Product change information (PCN)

PCN No.:	N0212075	Date:	11.06.2019
Products:	SAC/NBC cables with molded straight X-coded heads

Changeover from shield sleeves to Advanced Shielding Technology (AST)

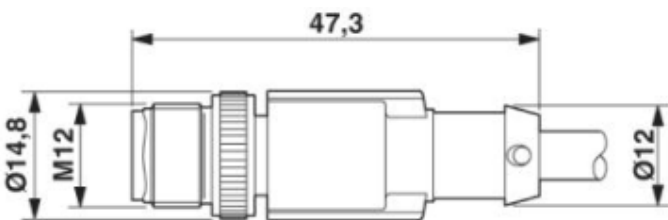
The shielding of the X-coded M12 heads will be changed from the previously used die-cast zinc shield sleeves to a molded metal shield (AST). This will ensure a higher-quality connection between the shielding braid of the cable and the M12 knurl.

With the introduction of the new AST shielding technology, the knurls will be changed over from SPEEDCON fast locking system to standard M12 threads. SPEEDCON and standard M12 threads are plug-in compatible.

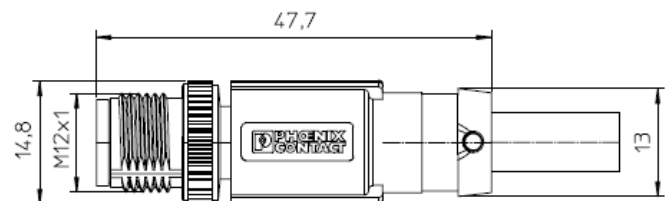
Previous production status

New production status
